MAINE TURNPIKE AUTHORITY

ADDENDUM NO. 1

CONTRACT 2022.07

INTERCHANGE IMPROVEMENTS

SHEET NUMBER: LP-07
252 OF 735

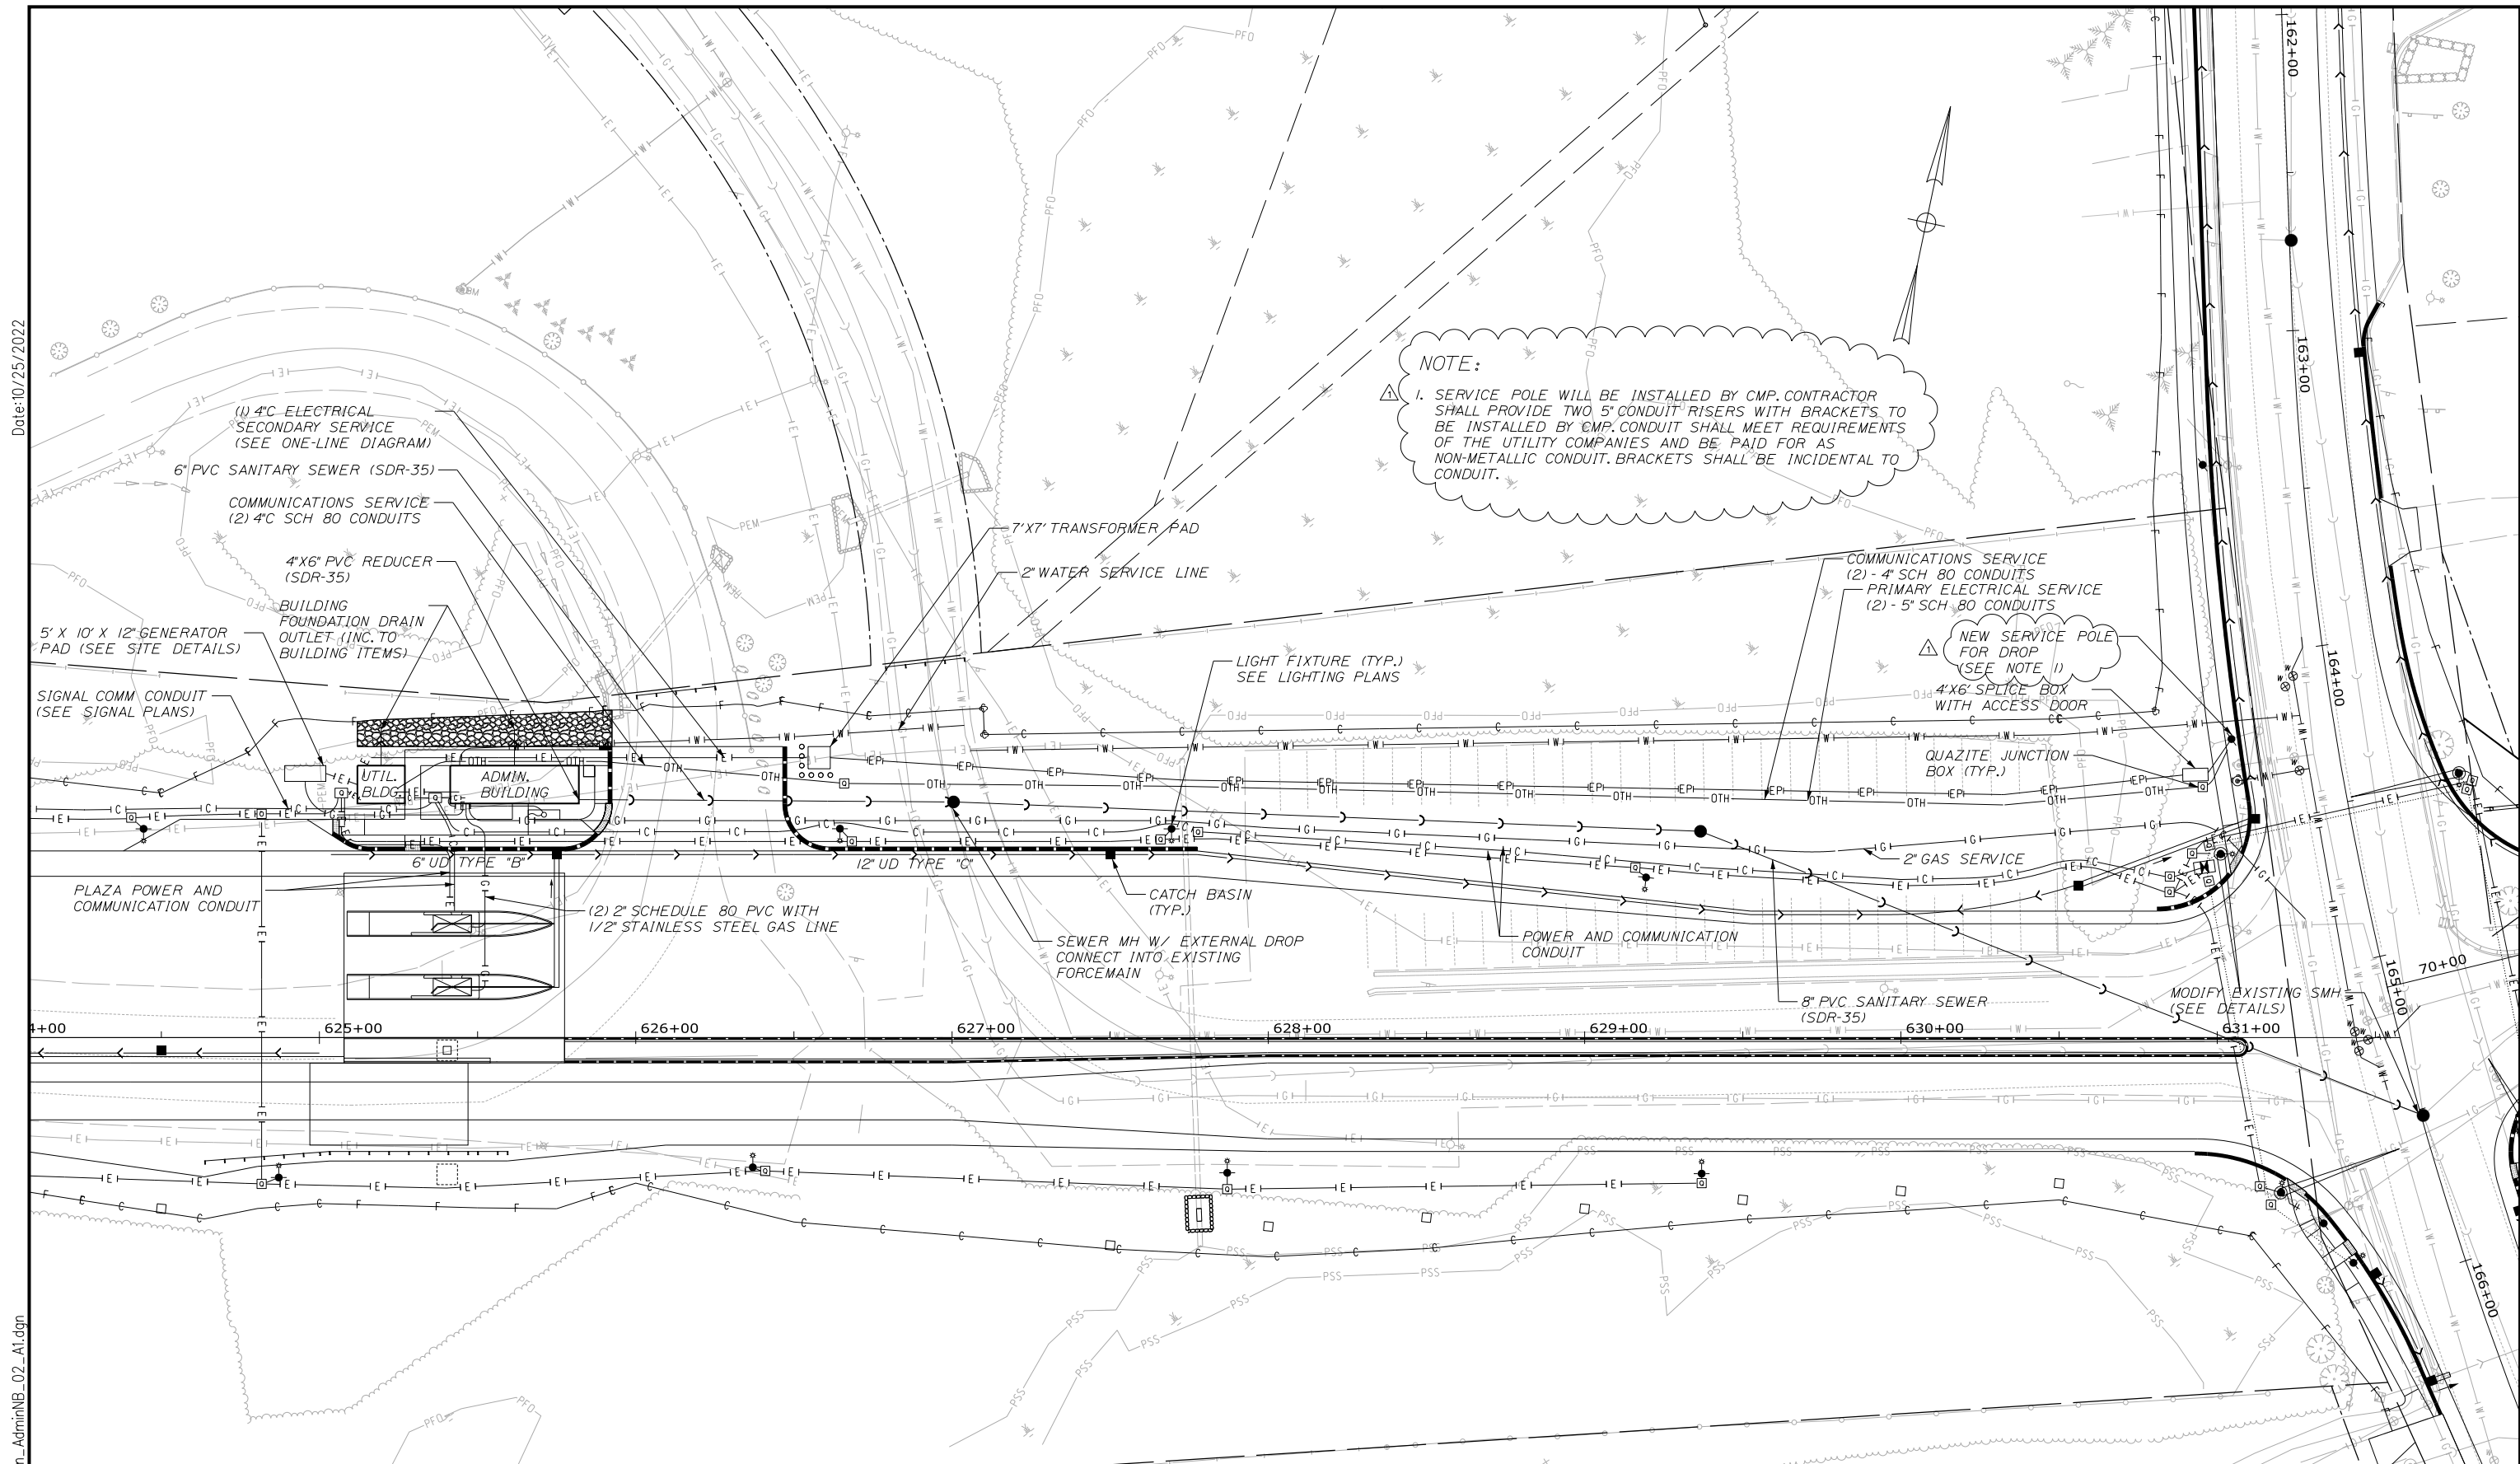
- Plan Sheet 10 of 735, CONSTRUCTION NOTES 2, has been deleted in its entirety and replaced with Plan Sheet 10 of 735, included in this addendum.
- Plan Sheet 252 of 735, POWER AND COMMUNICATION PLAN 6, has been deleted in its entirety and replaced with Plan Sheet 252 of 735, included in this addendum.

21. Question: Sheet 252- Can you provide some clarity on the Co-Locate at Station 166+00. Could this be a remove and reset item?

Answer: The co-locate note will be deleted on Sheet 252 in Addendum No. 1.

CONTRACT: 2022.07
 SHEET NUMBER: SP-02
 280 OF 735

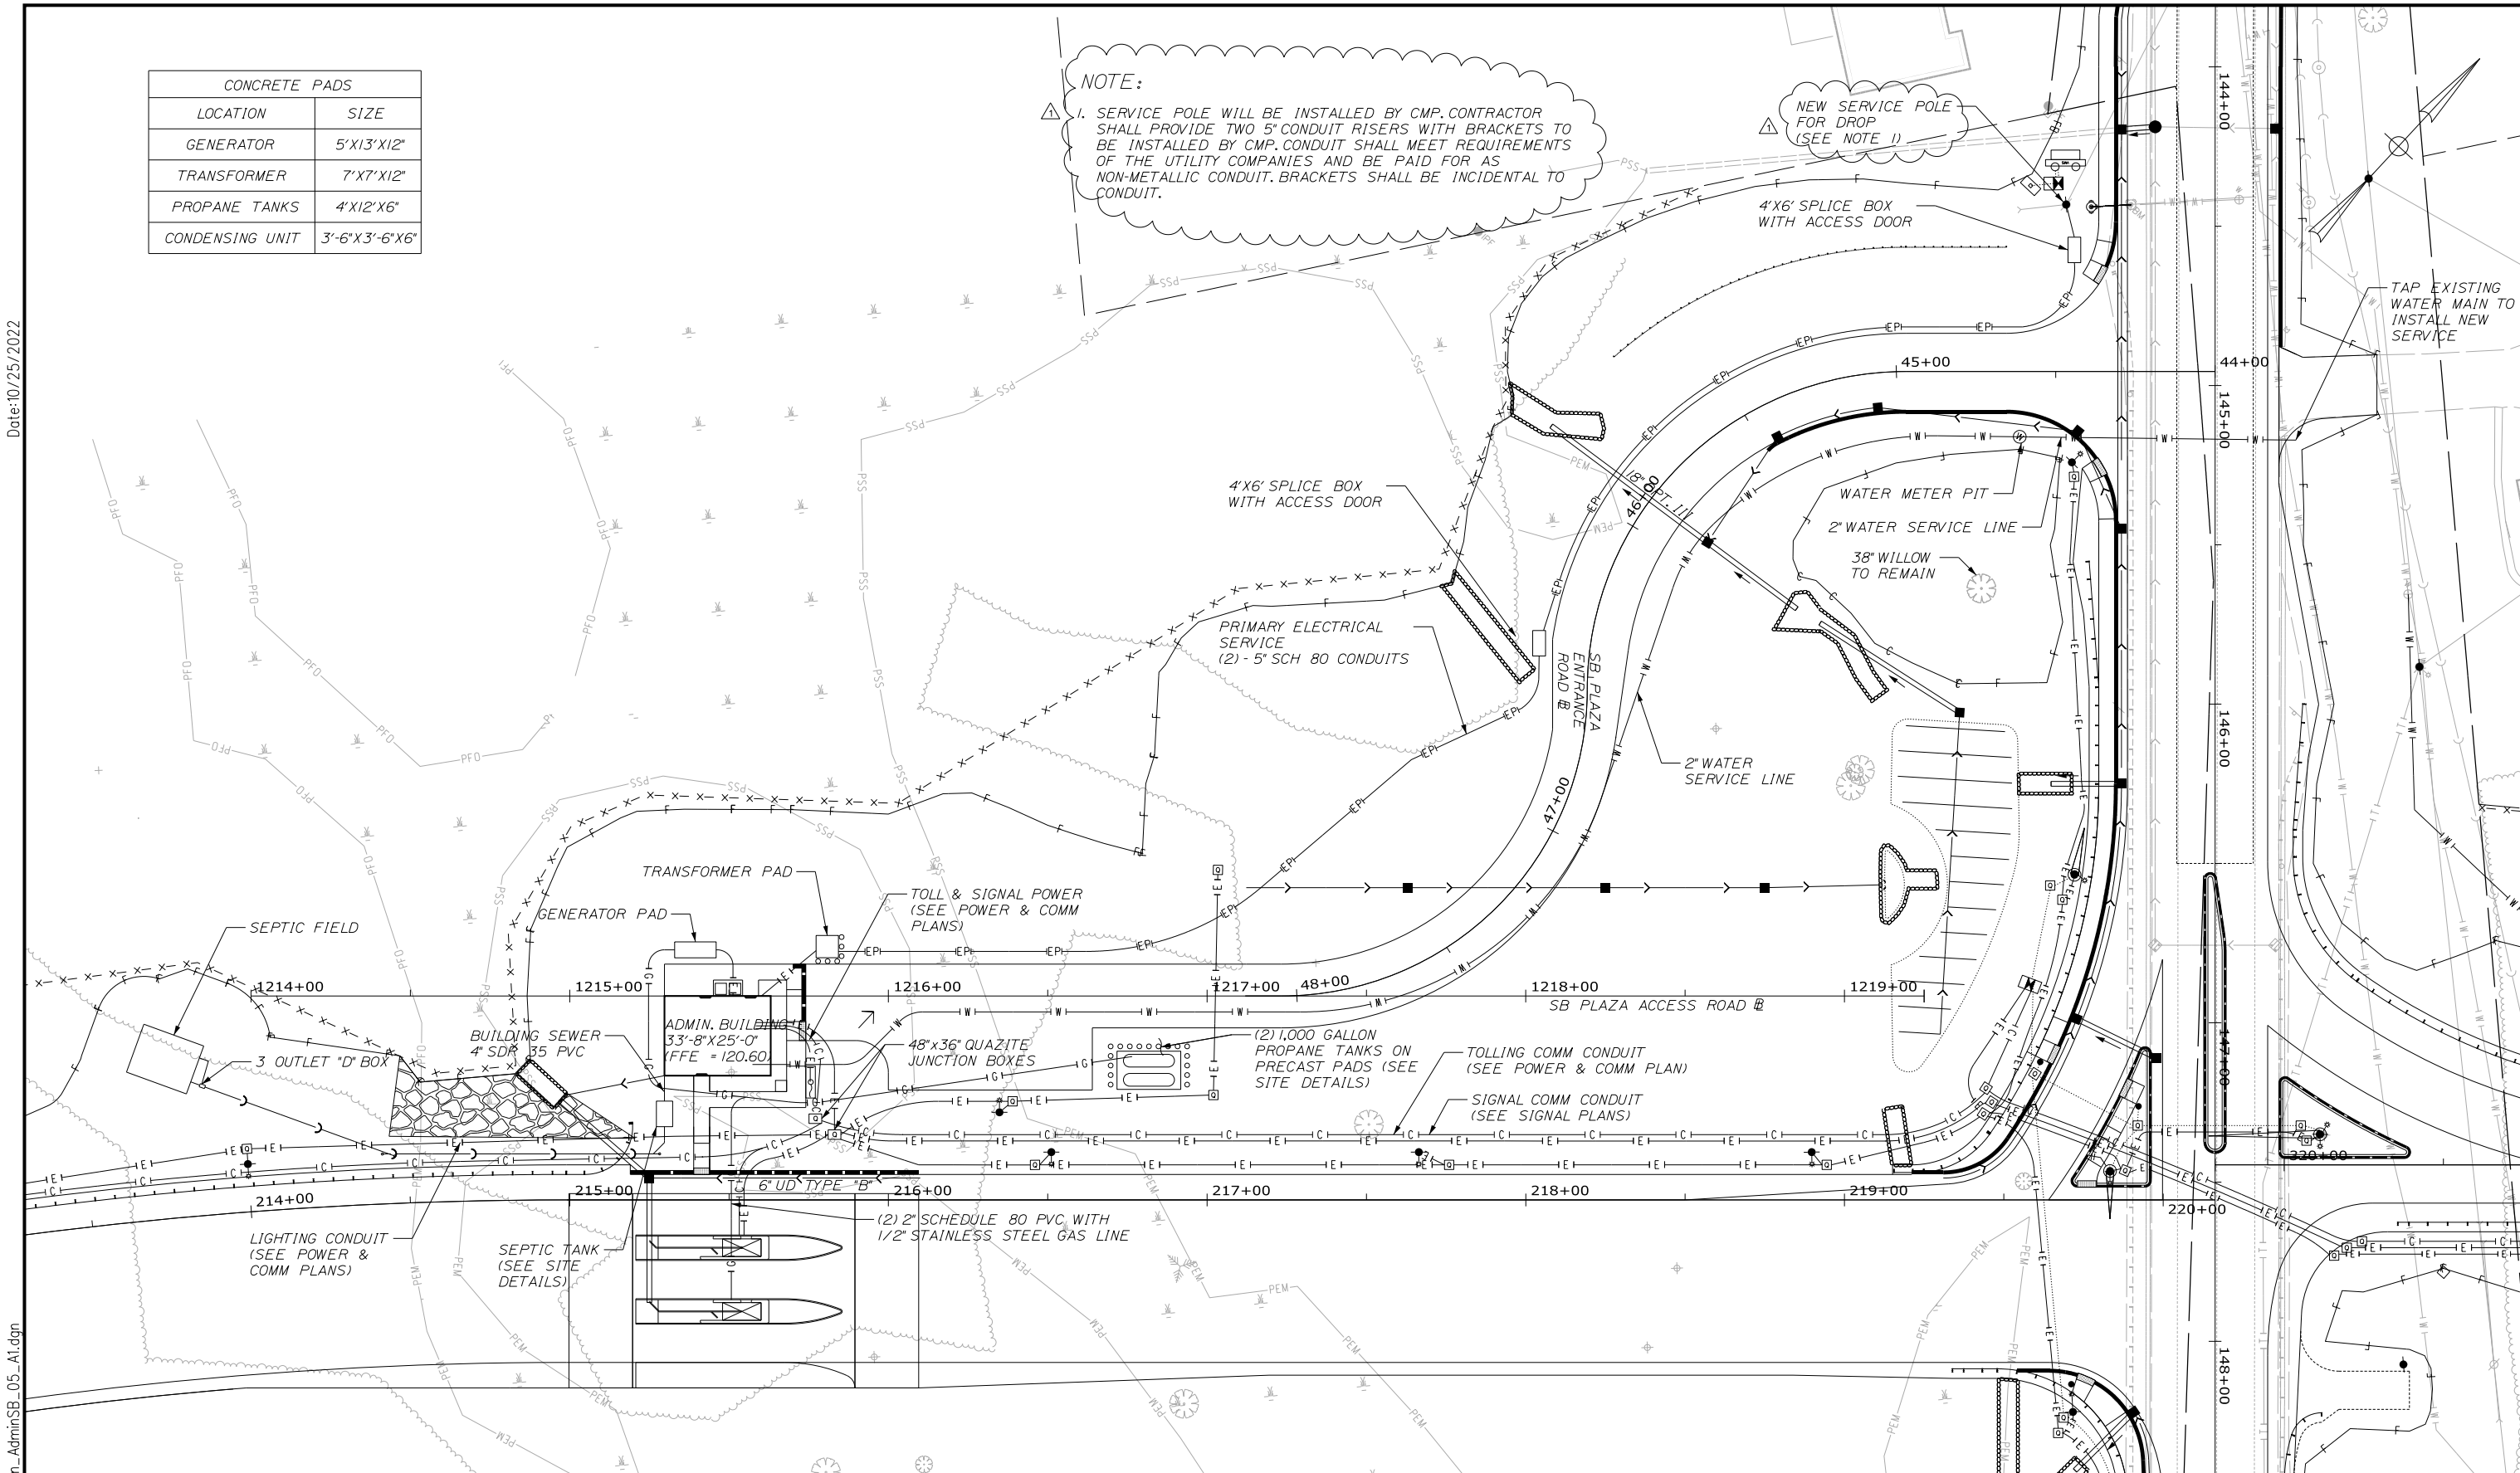
- Plan Sheet 280 of 735 ADMIN BUILDING NB SITE UTILITY PLAN, has been deleted in its entirety and replaced with Plan Sheet 280 of 735, included in this addendum.

7. Question: Is the pole on 280 of 735 by us or by CMP?

8. Question: Need rigid steel conduit and standoff brackets for risers up poles. No pricing line items requested for these items.

Answer: New service pole will be set by Consolidated Communications as part of larger pole relocation effort along Route 112. See Utility Pole list on page SP-11 of the bid book.

Answer: Plan sheets 3, 280, and 284 are updated in Addendum No. 1 to include the risers.

NOTE:
 1. SERVICE POLE WILL BE INSTALLED BY CMP. CONTRACTOR SHALL PROVIDE TWO 5" CONDUIT RISERS WITH BRACKETS TO BE INSTALLED BY CMP. CONDUIT SHALL MEET REQUIREMENTS OF THE UTILITY COMPANIES AND BE PAID FOR AS NON-METALLIC CONDUIT. BRACKETS SHALL BE INCIDENTAL TO CONDUIT.
